UNITED STATES PATENT AND TRADEMARK OFFICE

10/595,366

Office Action Summary

DETAILED ACTION

ATTACHMENT A

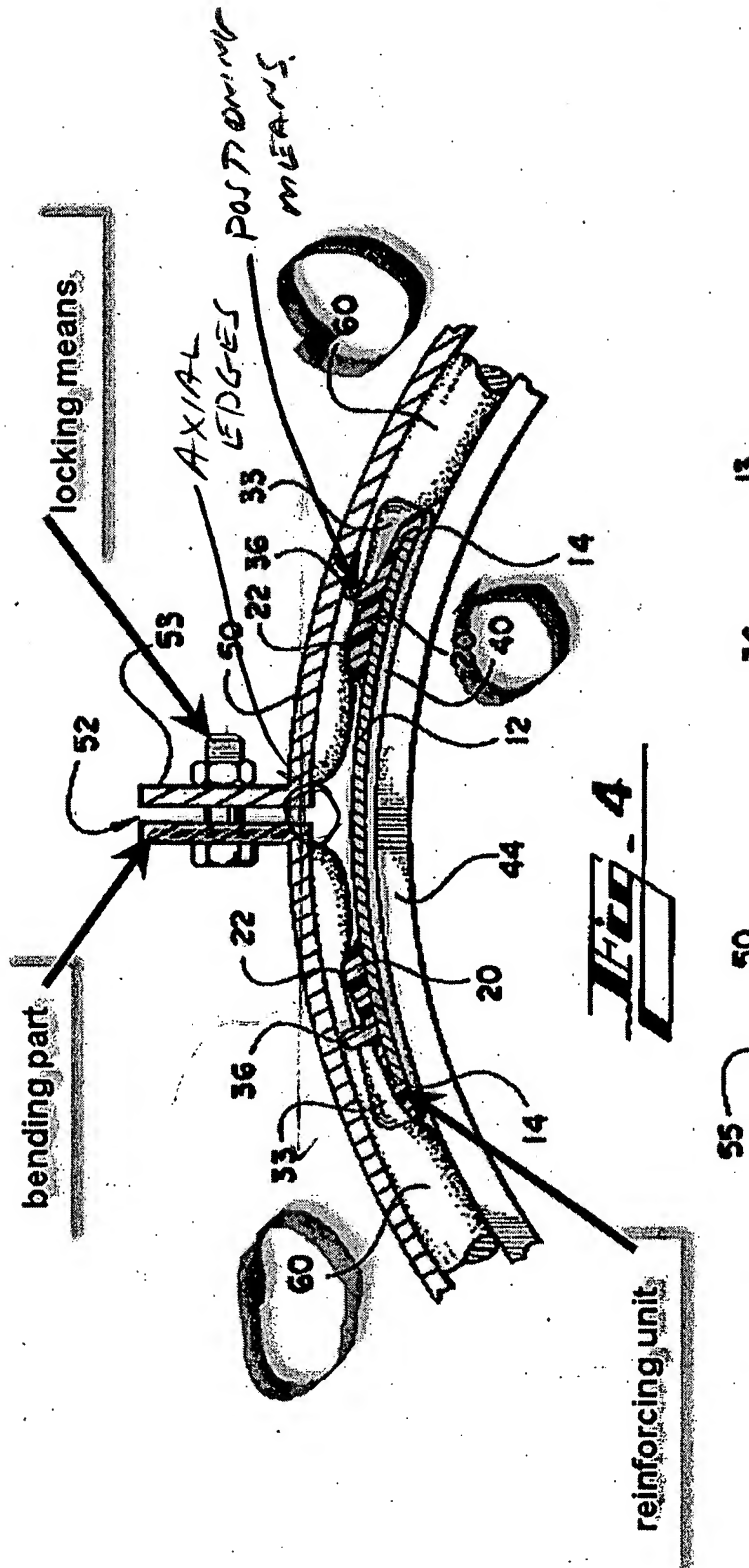
In regard to claims 1, 3/1, 4/1, 4/3/1, 6/1, 6/3/1, and 7/1, as best understood Bridges discloses in Figures 1, 4, and 6, see Attachments A, B, and C, a pipe joint, comprising:

a body part (see Attachment A) provided by rolling a planar material to form a cylindrical structure, the body part having a pair of opposing circumferential edges and a pair of opposing axial edges (see Attachments B and C), the axial edges of the body part defining a longitudinal slot, the body part defining a longitudinal axis (see Attachment C) extending between the pair of opposing circumferential edges, the body part further defining a transverse axis (an arbitrarily chosen exemplary transverse axis noted in Figure 6, see Attachment C) extending between the pair of opposing axial edges of the body part;

a reinforcing unit (see Attachment B) comprising a separate curved plate, the reinforcing unit being reduced in thickness at both ends thereof (see Attachment B) to be in close contact with an inner surface of the body part, the reinforcing unit having a pair of opposing circumferential edges and a pair of opposing axial edges (see Attachment A to observe the respective edges), the reinforcing unit defining a longitudinal axis extending between the pair of opposing circumferential edges (an arbitrarily chosen exemplary longitudinal axis noted in Figure 1, see Attachment A), the reinforcing unit further defining a transverse axis extending between the pair of opposing axial edges of the body part (an arbitrarily chosen exemplary transverse axis noted in Figure 1, see Attachment A);

the reinforcing unit further comprising positioning means (as noted in Figures 1 and 4, see Attachments A and B) extending longitudinally along at least a portion of an outer surface of the reinforcing unit and having a stepped shape (best observed in Figure 4, see Attachment B), the positioning means facilitating the horizontal positioning of the reinforcing unit with respect to the body part when the stepped shape of the positioning means aligns with at least a portion of the longitudinal slot of the body part;

ATTACHMENT C

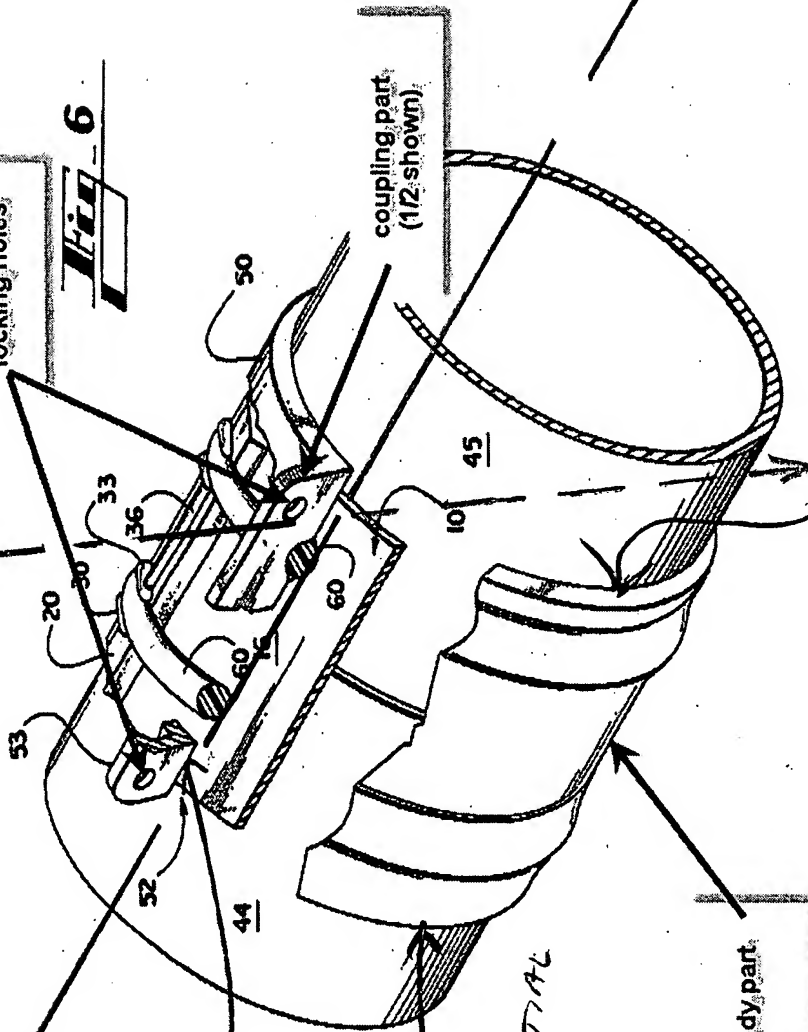
a coupling part (see Attachment C) having a bent surface (the coupling part comprising the noted "bent part" in Figure 4, see Attachment B) at each of both ends of the body part, with a plurality of locking holes (see Attachment C) provided on the bent surface of the coupling part;

ATTACHMENT D

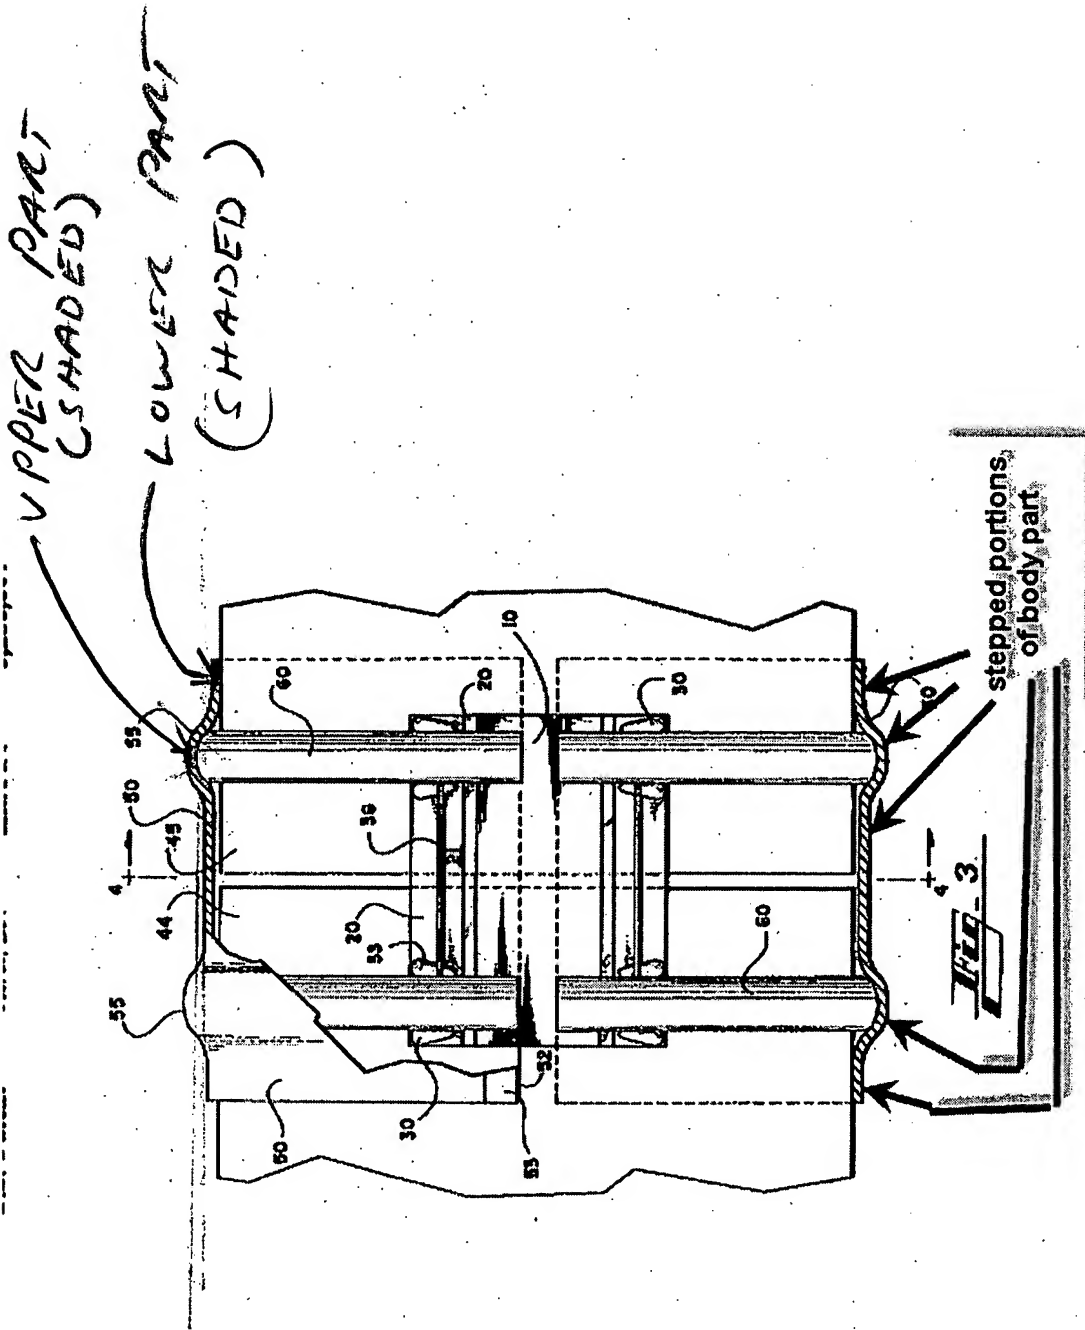
the body part is stepped (see Attachment D) around a predetermined portion thereof so that upper and lower parts of the body part differ in inner and outer diameters from each other (as observed in Figure 3, see Attachment D), each of the upper and lower parts having a consistent diameter (the noted shaded areas have consistent diameters) and defining substantially concentric, graduated parts such that the consistent diameter of one part is greater than the consistent diameter of the other part (as observed in Figure 3, see Attachment D);

ATTACHMENT E

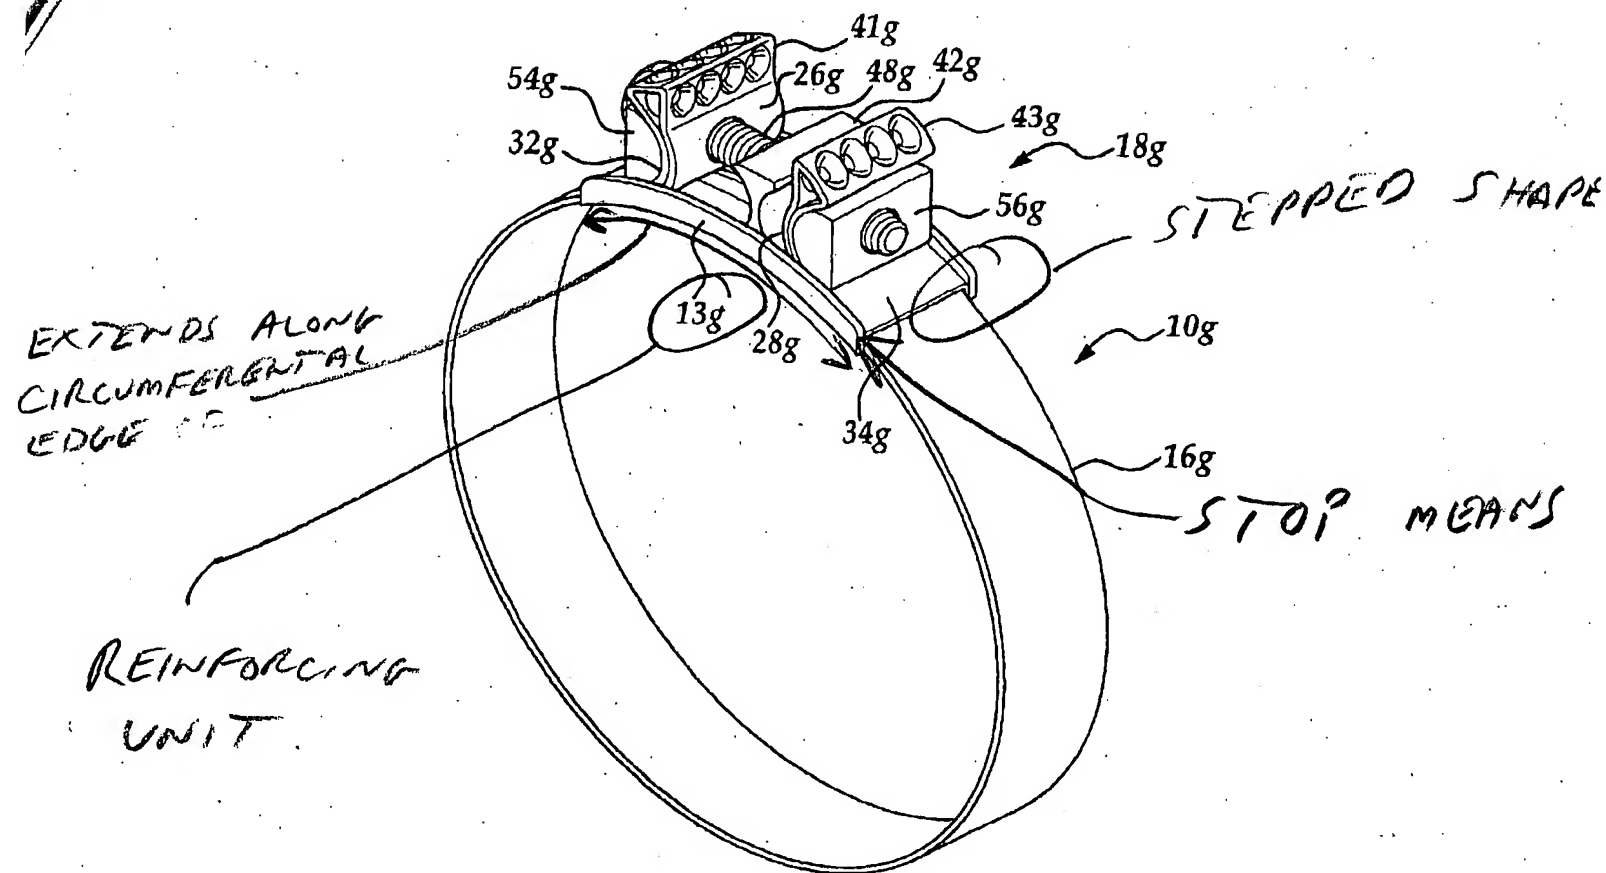
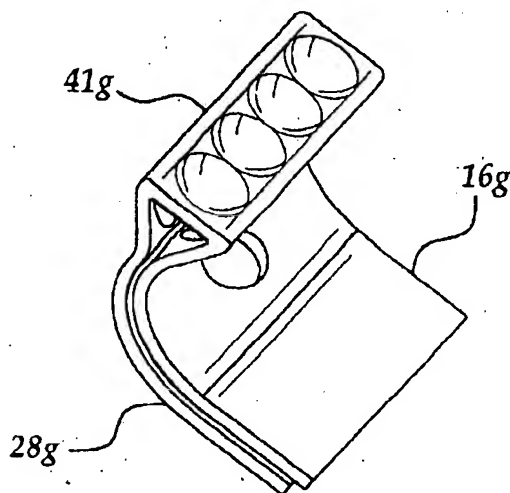
and structurally operates under the same principles, with a reinforcing unit (13g in Figure 18, see Attachment E) having a stop means with a stepped shape and extending along the circumferential edge of the reinforcing unit to bridge across the tightening mechanism (column 9, lines 60-66). It would have been obvious to one having ordinary skill in the art at the time the invention was made to modify the reinforcing unit as provided for by Bridges in view of Morris with the stop means as taught by Cassel et al to bridge across the tightening mechanism.
